ULTRA LEVEL TECH.CO.,LTD.

Subject:	Product Change Notice (PCN)	Date:	2017/9/12
-----------------	------------------------------------	--------------	-----------

PRL1103x-y and PRL1103Dx-y (x=U, E or F; y=12, 15, 24, 36, 48, 0512 or 1224) series

For U & F type - Current terminal block-

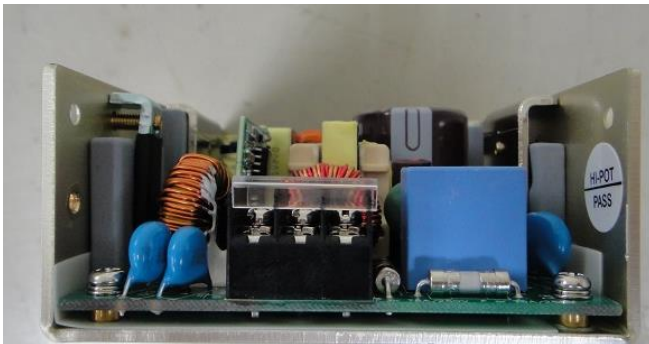
Input terminal block connector change for IEC 60601-1: 2005+ A1, EN60601-1: 2006+A11+A1+A12 requirement.

IEC 60601-1: 2005+ A1, EN60601-1: 2006+A11+A1+A12 requires input connector needs to have European approval (TUV, VDE or EN/EC etc..). **New connector does not have plastic cover.**

New terminal block-

All shipment after Jan, 1, 2018 will be with new terminal block.
